**TOWN OF NEWBURGH
PLANNING BOARD
REVIEW COMMENTS**

PROJECT: GARDNER RIDGE
PROJECT NO.: 02-29
PROJECT LOCATION: SECTION 75, BLOCK 1, LOT 4.12
REVIEW DATE: 12 JUNE 2017
MEETING DATE: 15 JUNE 2017
PROJECT REPRESENTATIVE: DOCE ASSOCIATES

**RE: Site Plan Review for Gardner Ridge, Route 32, Town of Newburgh, NY;
Town Project No. 2002-29, CM Project No. 114-014 & 02-068**

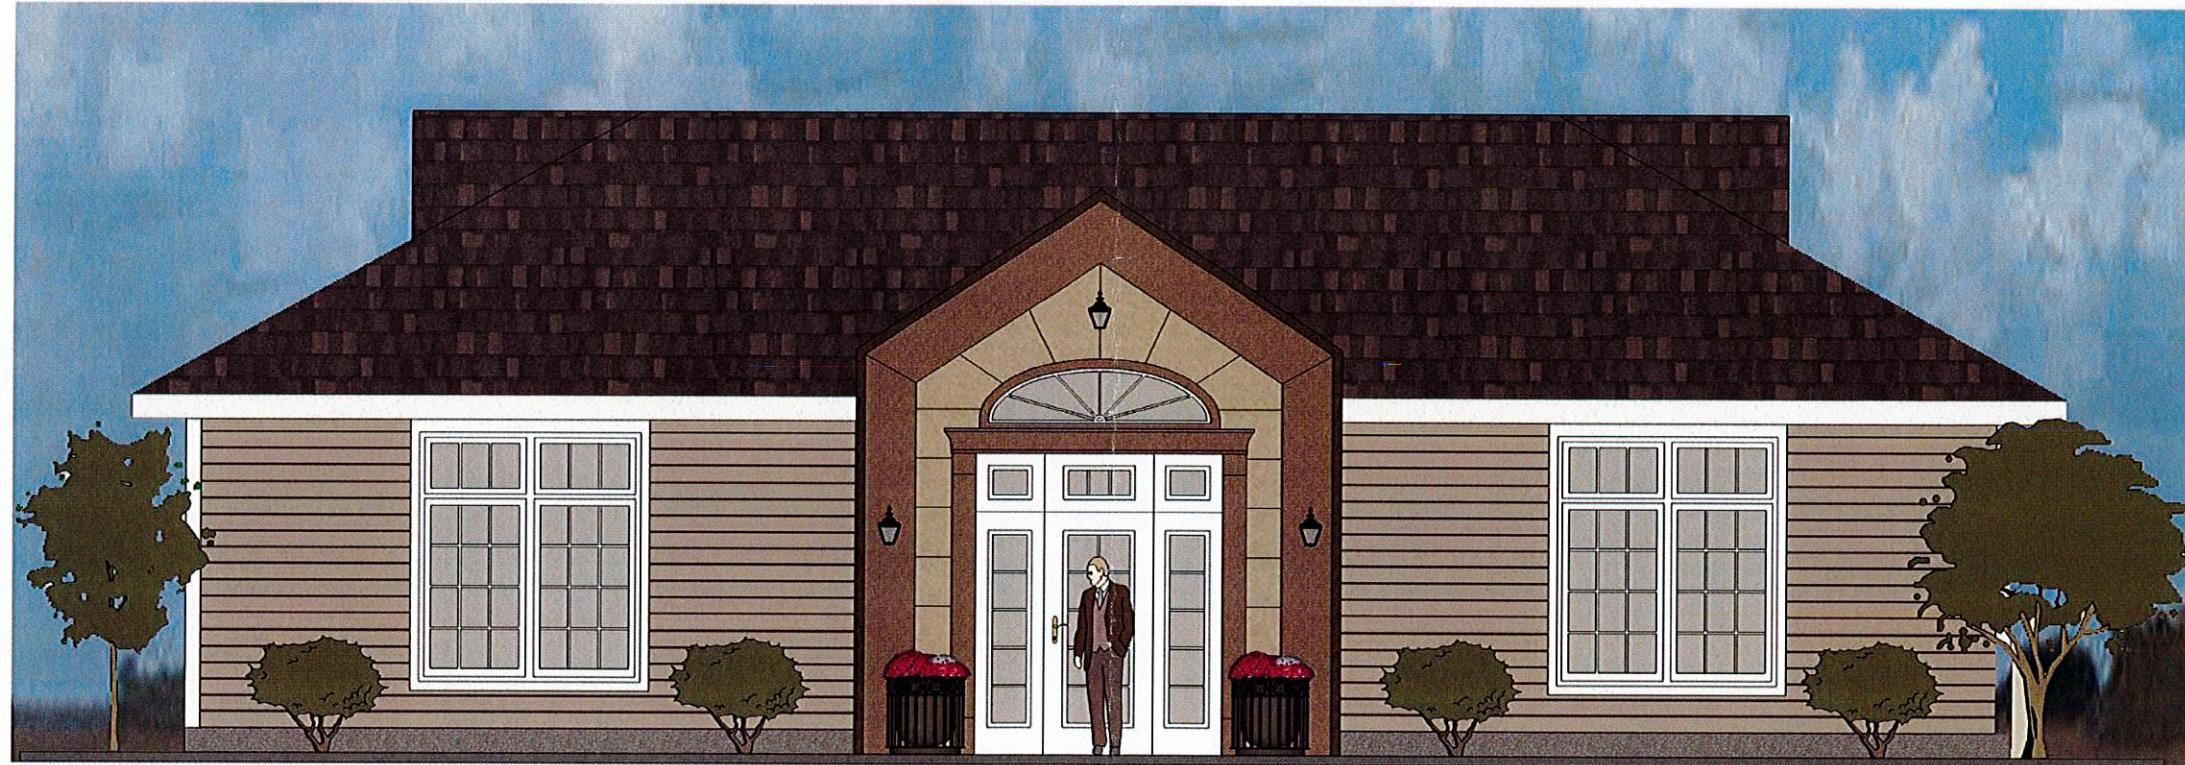
1. The property extends to the centerline of Gardnertown Road. Will a portion be dedicated to the Town to establish a proper ROW?
2. The entrance from Route 32 intersects at a 90 degree angle (see image right). Why isn't a curve proposed for inbound traffic? Are there future plans or opportunities to extend the site road north or west into WPA Acquisition Corp?

BIORETENTION SYSTEM DETAIL
NOT TO SCALE

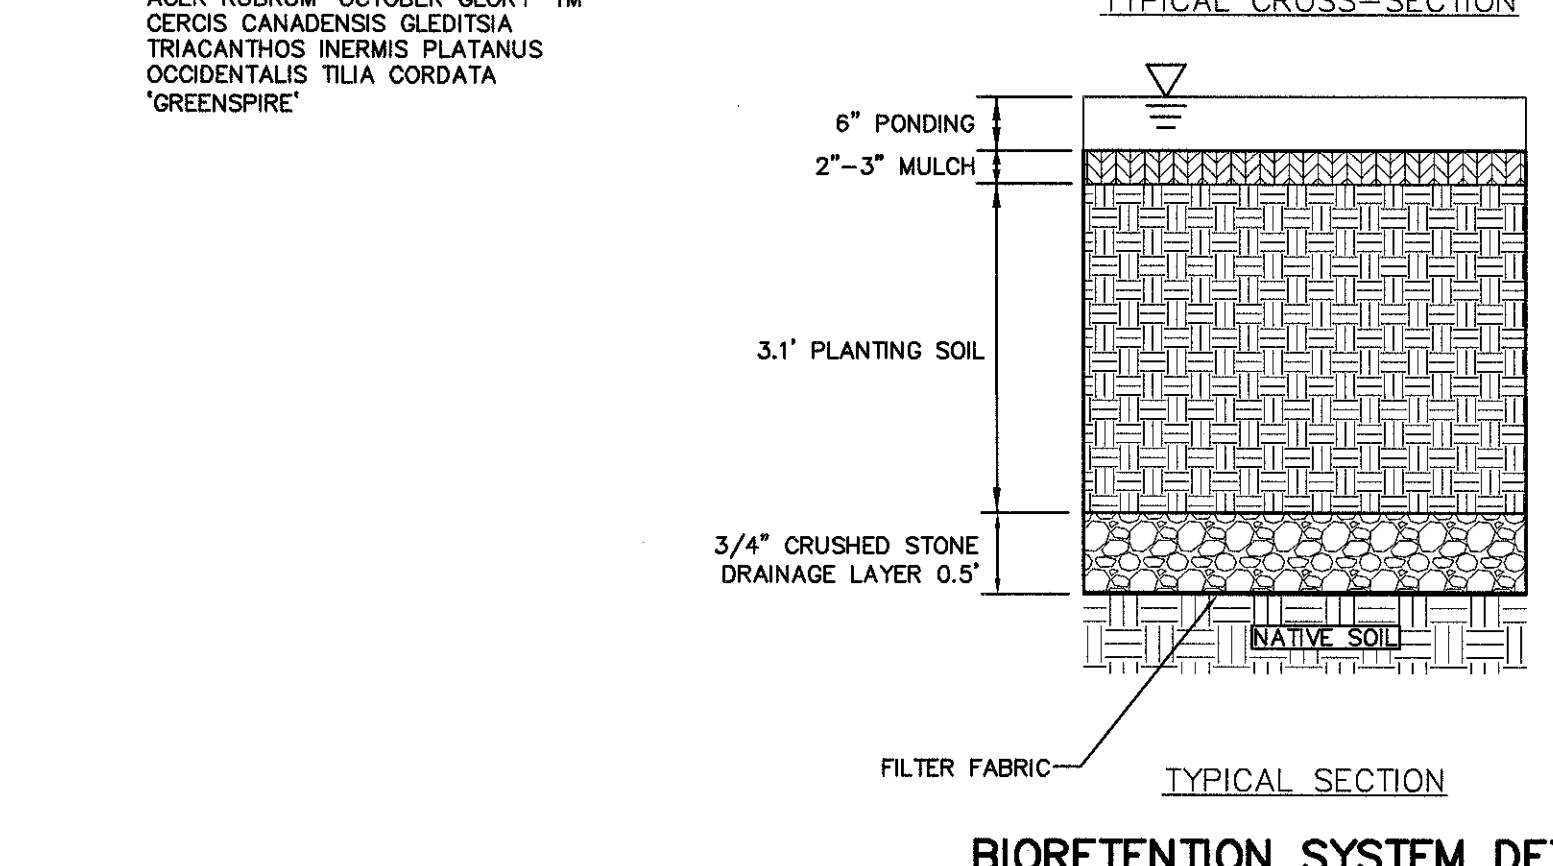
3. Underdrains are identified as being utilized within the bio retention systems. Detail does not contain the underdrain system. All pipes in the vicinity of the Stormwater management facility should be labeled with inverts, pipe sizes and material.
